20-016 Walthamstow Care Sites - Hurst Road
Design and Access Statement - Addendum v3
July 2023; updated August 2023; updated September 2023

This Addendum supercedes the relevant sheets of the submitted Design and Access Statement and summarises the amendments made through discussions with LBWF since January 2022.

4.0 Layout - addendum

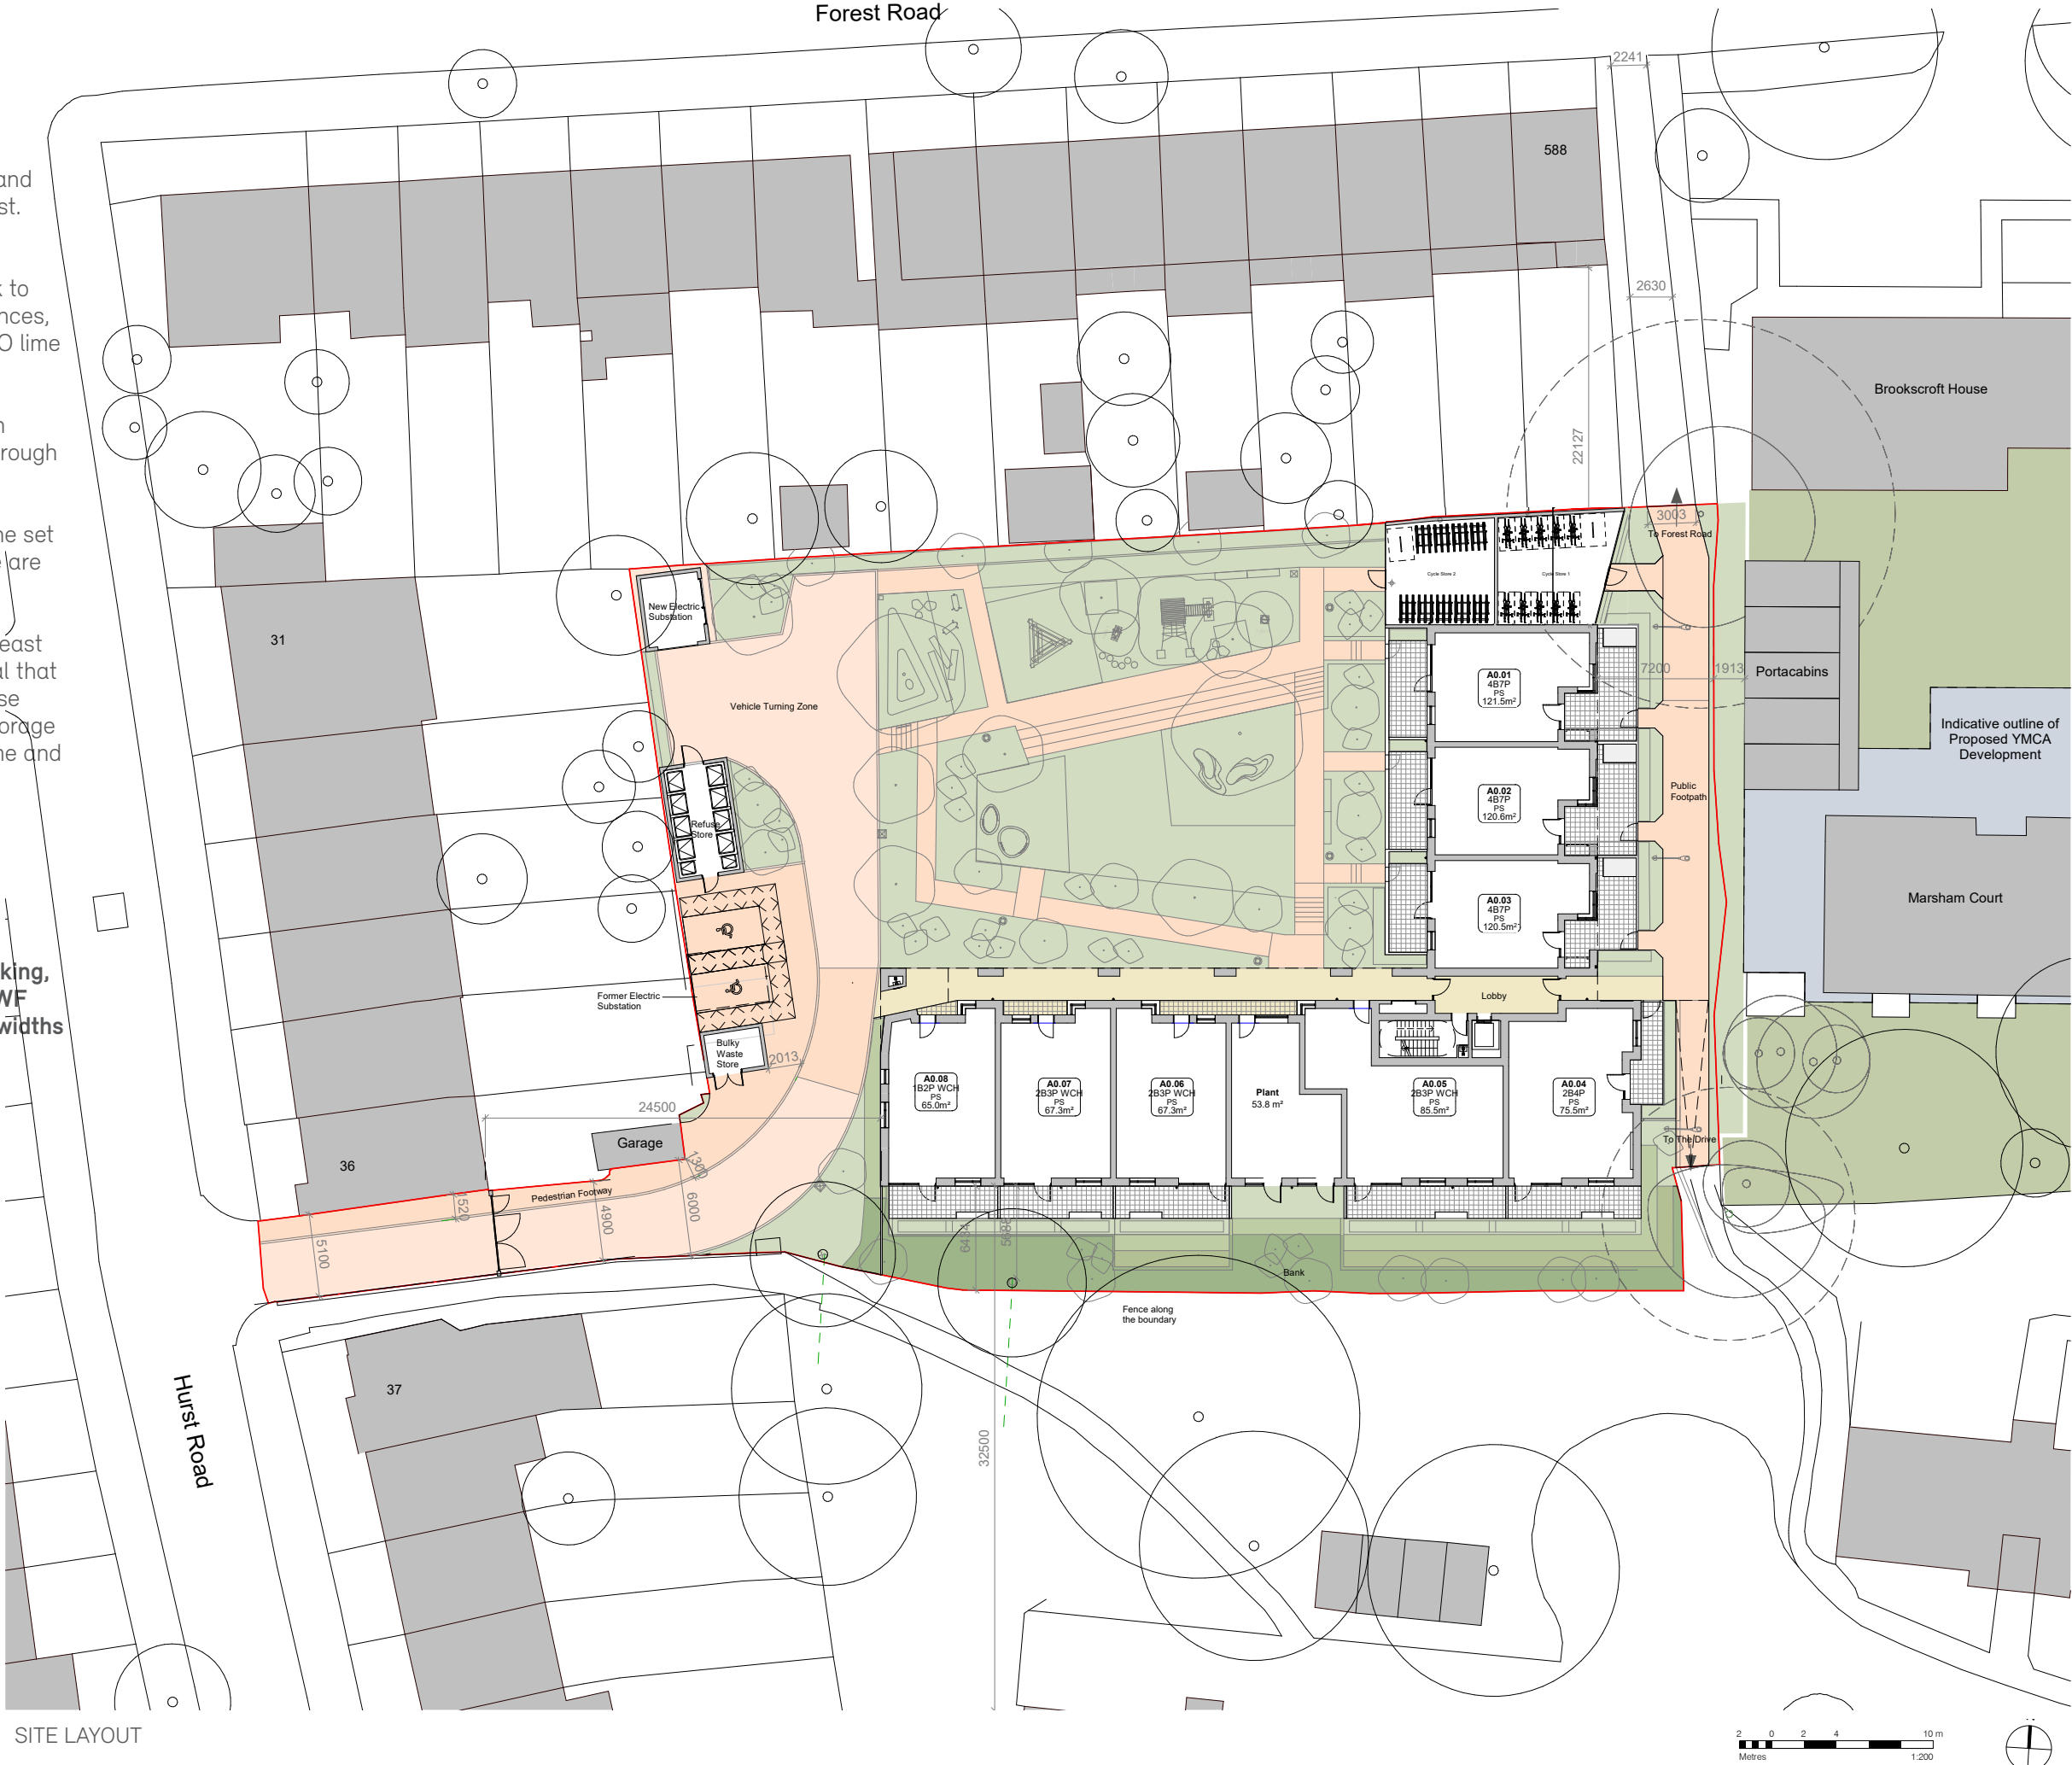
Updates: The arrangement of refuse, wheelchair parking, and substation position reflect the dialogue with LBWF planning and highways. Dimensions added note the widths of pedestrian paths as requested.

GROUND FLOOR PLAN

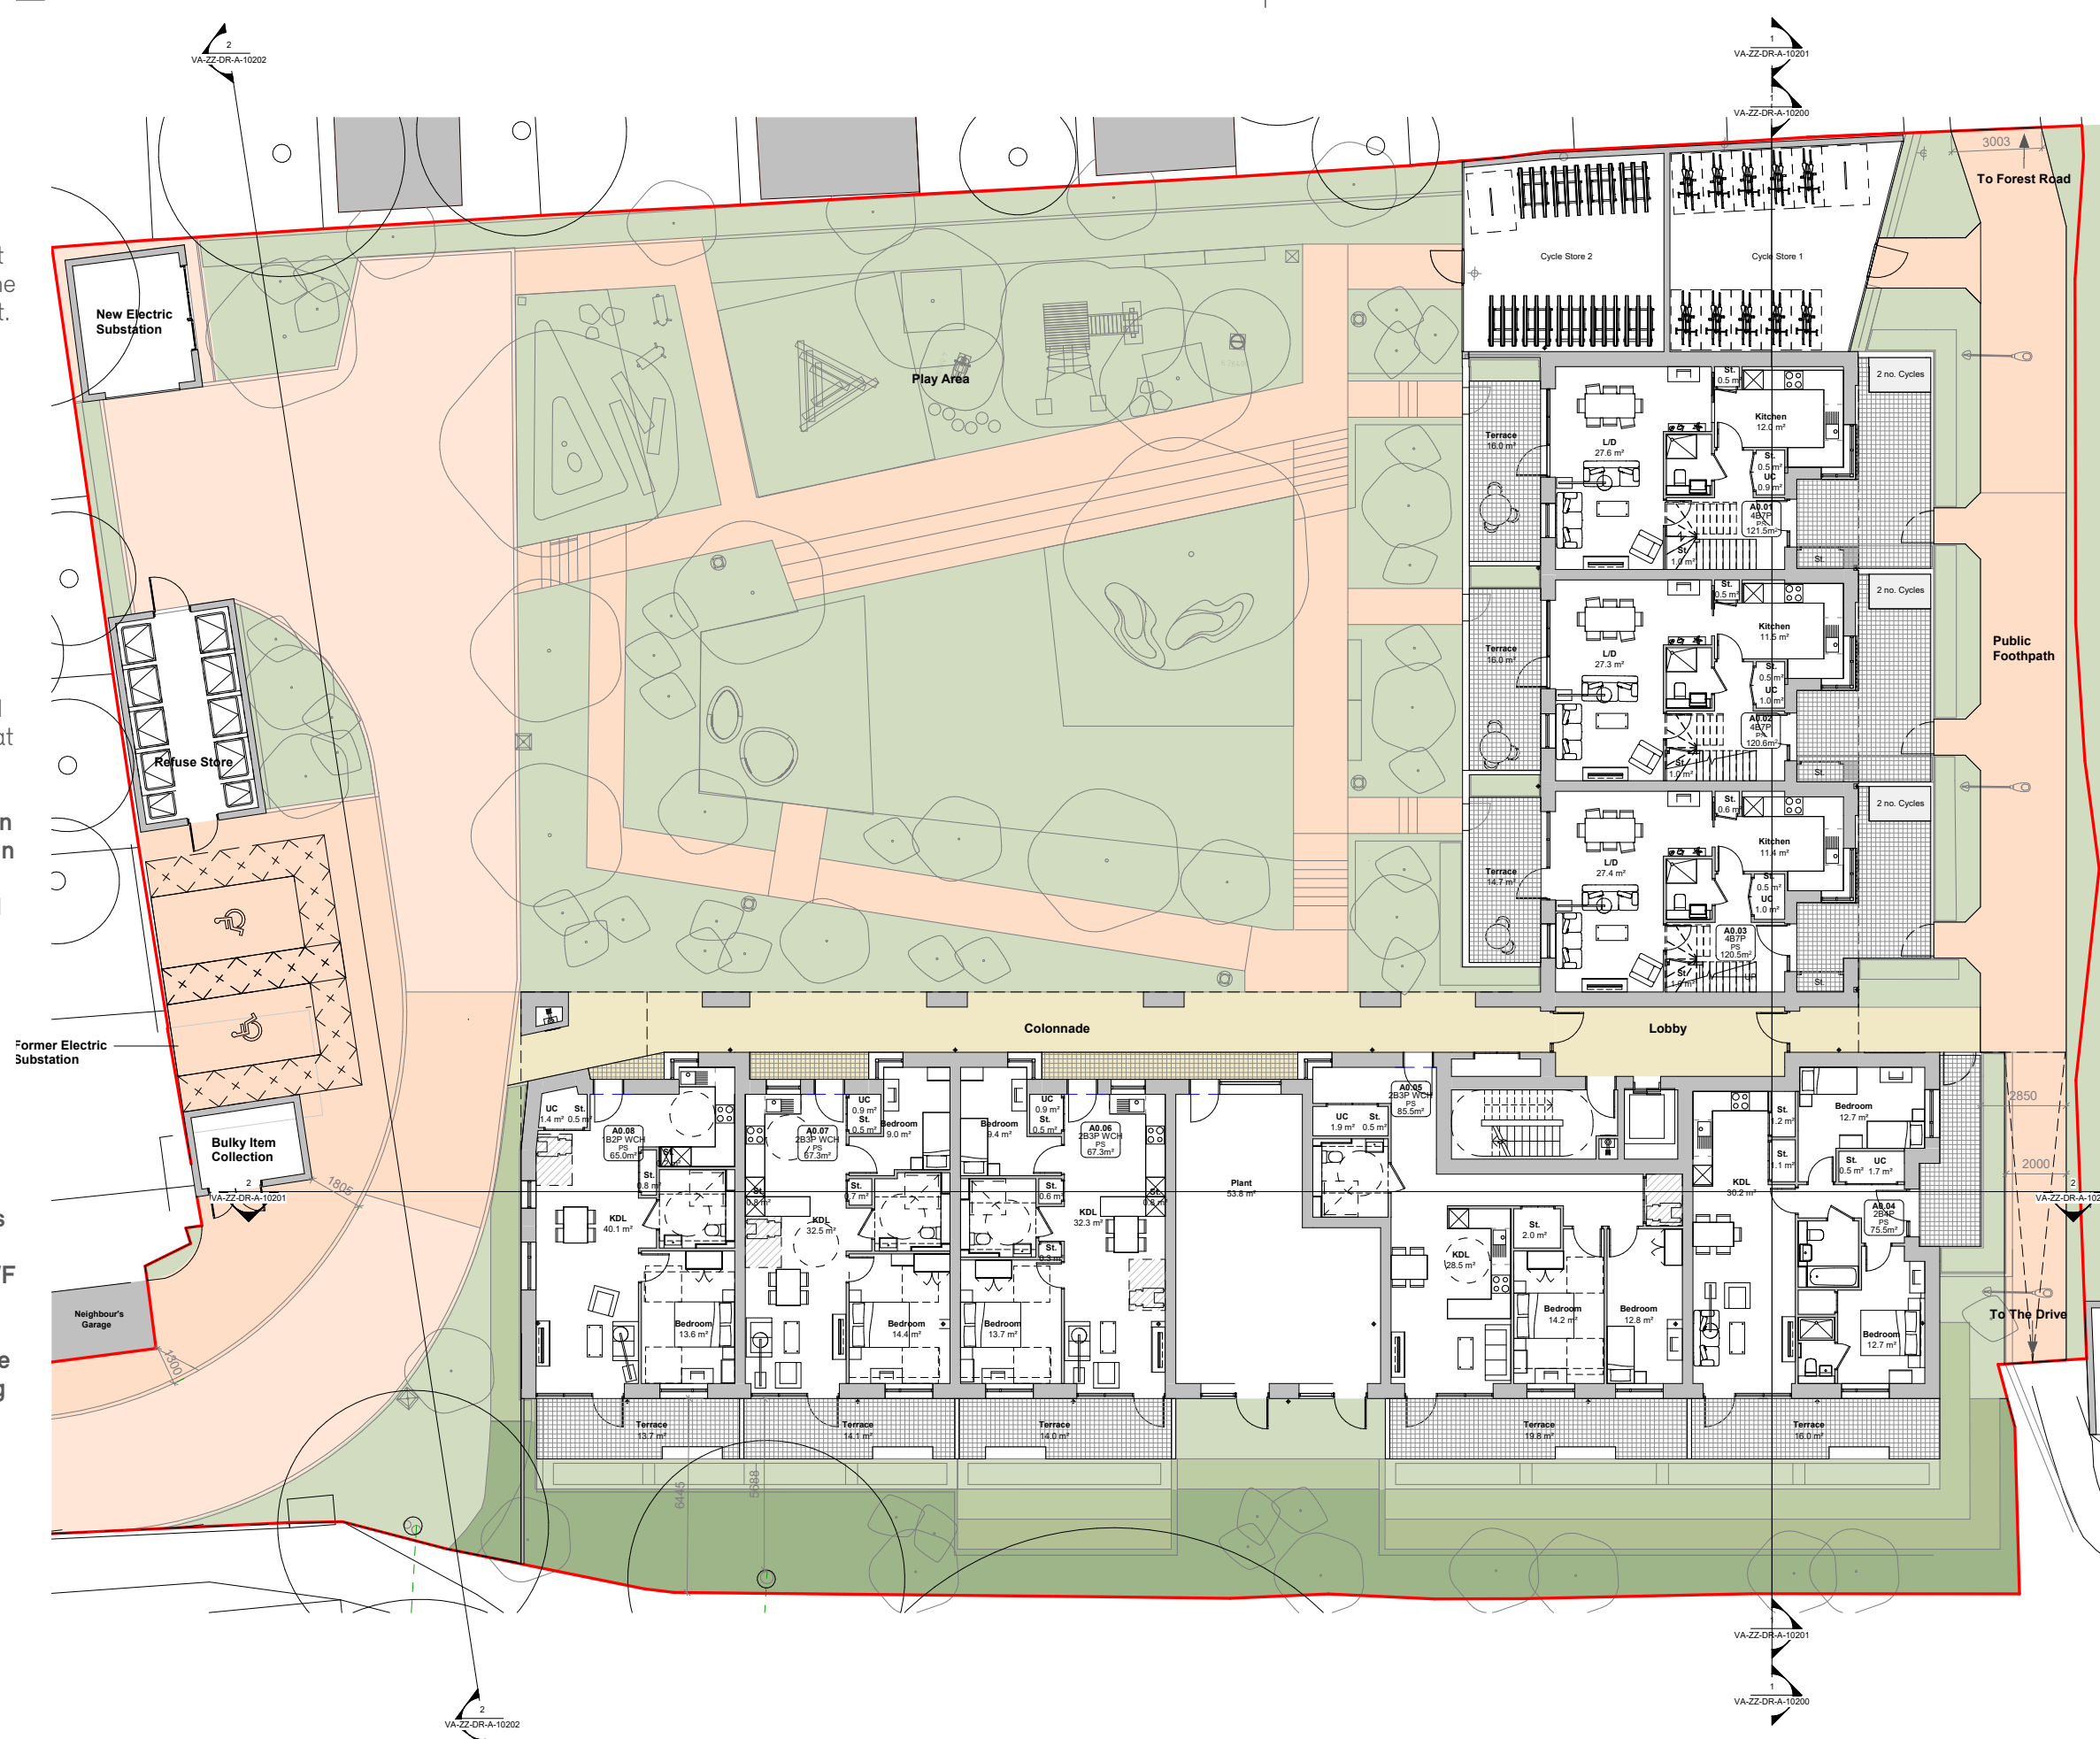
Update: The cycle storage in the north east of the site can be accessed from either the pedestrian path or from within the landscaped courtyard. There is no route through the cycle store into the site. This is as agreed with LBWF and the DOCO.

Update: The ground floor plans reflect the revised layouts of the arrangement of refuse, wheelchair parking, and substation position, in response to the dialogue with LBWF planning and highways.

Update Sept 2023: the internal layout of the cycle storage updated in accordance with LBWF highways and planning comments.

Windows - update:

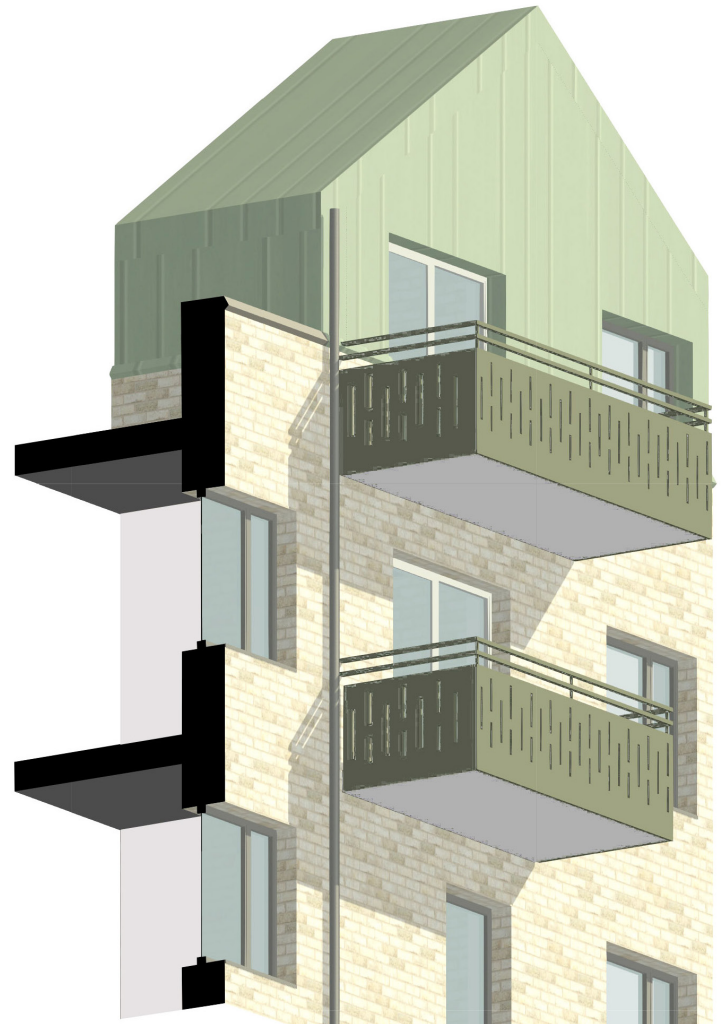
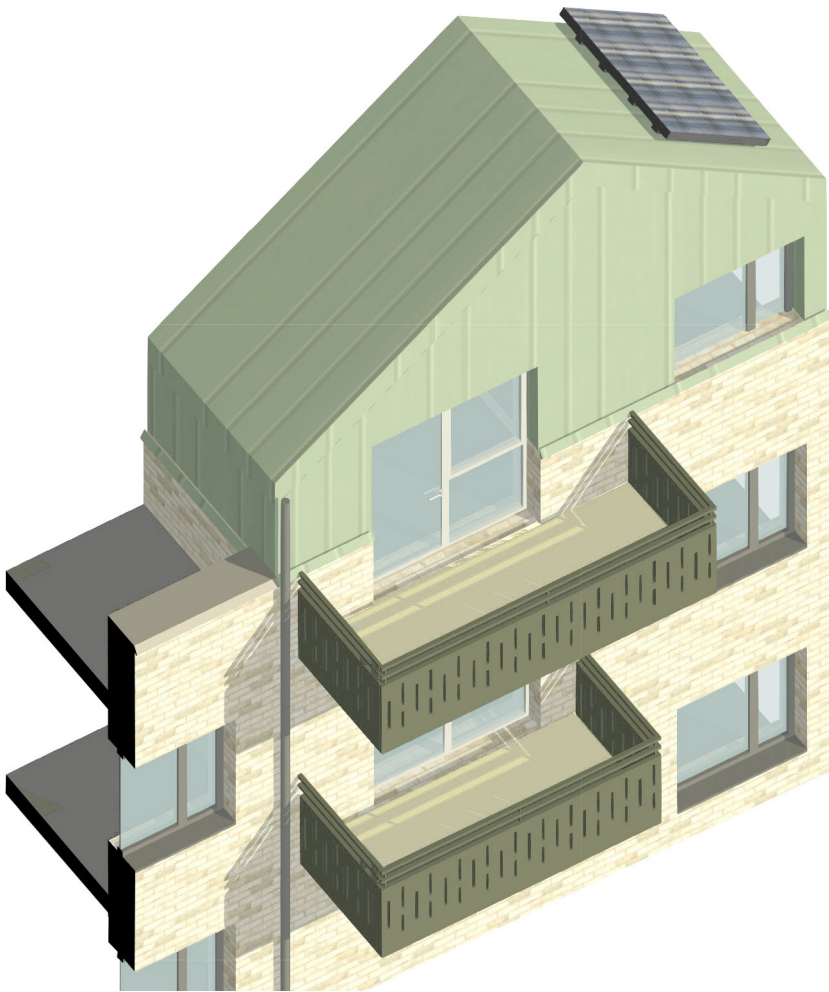
LBWF requested further detail on on the window reveals and cill projections.

As indicated in previously submitted elevations and visuals the windows will be set back 180mm from the face of the brickwork and the aluminium cills to the windows will project 35mm beyond the face of the brickwork.

The pre-cast cills sit within the punched openings of the gallery access only, not to window openings - as noted on annotated elevations previously submitted.
